# Access Compliance Report

## Public Rights-of-Way

### (Curb Ramps)

Intersection ID: 44470	Main Street: COREY_COMMON_AV	Cross Street: NEWFIELD_ST	Location: S
ADA ID: 3DD2D080F946	Ramp Type: PerpDiag	Initial Pass/Fail: Fail	Overall Compliance: No
		Severity Score: 8.75

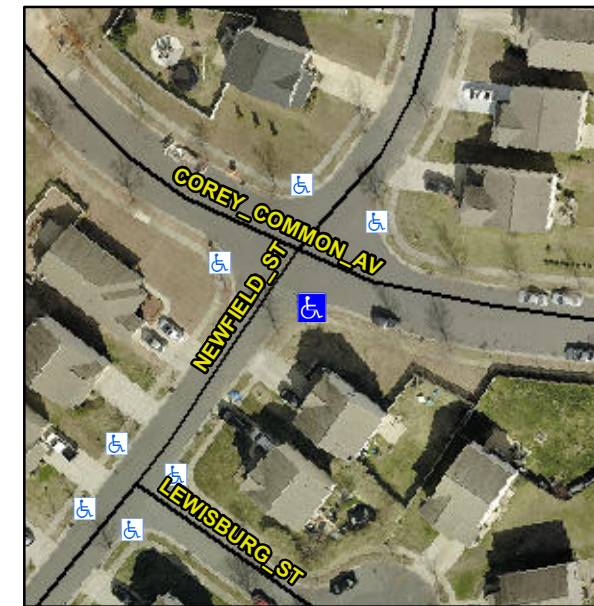
**R304.5.1**

Compliance	Description	Data	Compliance	Description	Data
N/A	Ramp Length (in)	48.0	Yes	Ramp Slope (%)	7.8
No	Ramp Width (in)	47.5	Yes	Ramp XSlope (%)	1.5
N/A	Flare Type LT	N/A	N/A	Flare Type RT	N/A
N/A	Flare Slope LT (%)	N/A	N/A	Flare Slope RT (%)	N/A
N/A	Flare Traversable LT?	N/A	N/A	Flare Traversable RT?	N/A
N/A	Landing Length (in)	N/A	N/A	DWS Provided?	N/A
N/A	Landing Width (in)	N/A	N/A	DWS Contrast?	N/A
N/A	Landing Slope (%)	N/A	N/A	DWS Length (in)	N/A
N/A	Landing X Slope (%)	N/A	N/A	DWS Full Width?	N/A
N/A	Landing Curb? (Y/N)	N/A	N/A	DWS Offset (in)	N/A
N/A	Shared Landing?	N/A			
N/A	Gutter Ponding?	N/A	N/A	Gutter Slope (%)	N/A
N/A	Gutter Lip Ht (in)	N/A	N/A	Gutter X Slope (%)	N/A
N/A	Painted X Walk1?	No	N/A	Painted X Walk2?	No
	X Walk 1 Direction	To NE		X Walk 2 Direction	To NW
N/A	X Walk 1 Width (in)	N/A	N/A	X Walk 2 Width (in)	N/A
	X Walk 1 Slope (%)	2.3		X Walk 2 Slope (%)	0.7
	X Walk 1 X Slope (%)	1.7		X Walk 2 X Slope (%)	3.3

**Remove & Replace Curb Ramp With Two New Directional Ramps or Equivalent.**
